Heavy Commercial Vehicles

Subject	Regarding to Retrofit of Smart Tachograph DTCO 4.1
Model	H476 – H566 – H625
Summary	Replacement of smart tachograph from DTCO 4.0 to DTCO 4.1 version in line with the EU directives.

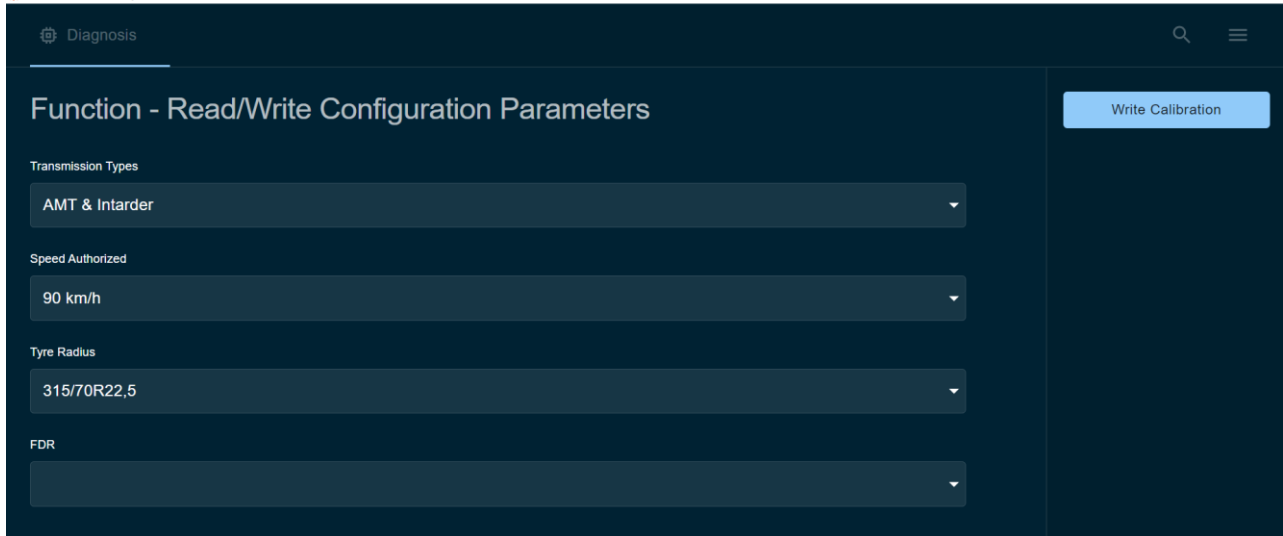
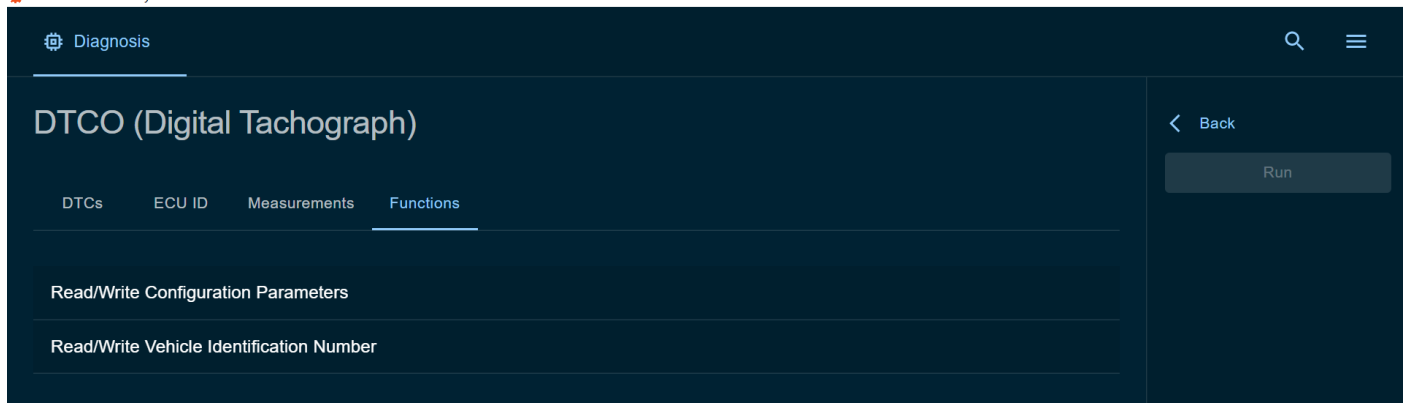
- In FMAX vehicles, the tachograph is located in the upper storage area, and in the Legacy vehicles the tachograph is located on the right console.
 - **Location of Tachograph in FMAX;**

- **Location of Tachograph in Legacy;**

- The old version DTCO 4.0 tachograph should be removed from its place with the help of tachograph rods.

- The electrical wiring connections and antenna wiring connectors should be unplugged from the DTCO 4.0 tachograph.

- The connections of the new version DTCO 4.1 tachograph will also be made with the old version tachograph sockets that have been removed. The connectors and antenna wirings of DTCO 4.0 should be plugged to the DTCO 4.1 version 2 smart tachograph.
- Make connection with FODIT and write parameters and VIN. Clear DTC's, Read DTC's and make sure that DTCO 4.1 has no DTC.

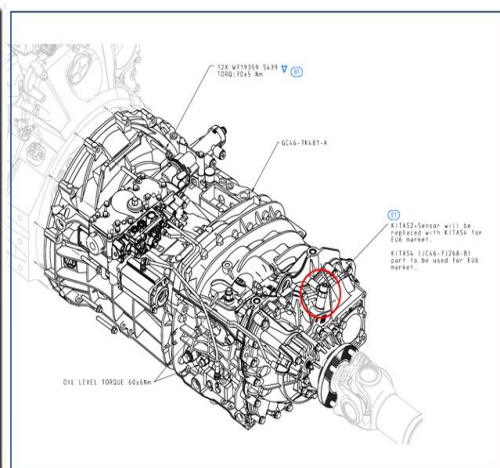
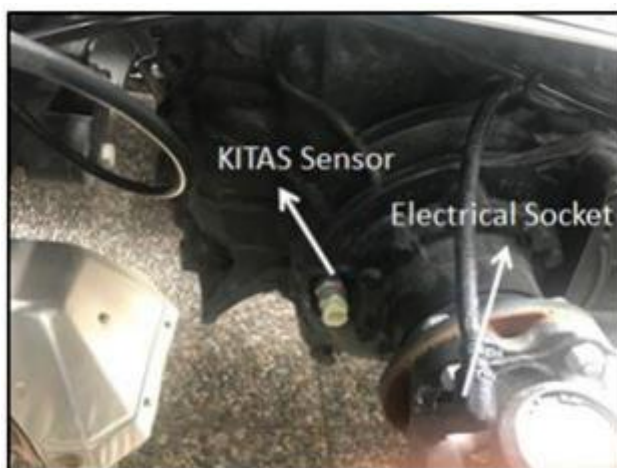
The process steps described so far are valid for the vehicles to be newly registered. The procedures to be explained here are for vehicles that already have a tachograph paired with a KITAS sensor. If a 2nd generation DTCO 4.1 tachograph is to be fitted to the vehicle, the existing KITAS sensor must also be replaced with the KITAS sensor specified in the parts to be used section in accordance with the transmission in the vehicle.

- Remove electrical socket from the sensor. Disassembly the sensor by using open-end wrench or ring spanner. Mount KITAS4 sensor in the place and tight via torque wrench. Tightening Torque: 40 +/- 6 Nm. (M18x1.5 Threaded Connection)

- Before tightening the sensor make sure that sensor is place to transmission housing properly and thread grooves are clean.
- Apply the electrical connection for the last steps of sensor change.
- Check the Smart Tachograph connections and confirm that the tachograph is running and that the speed information is equivalent with the dial.
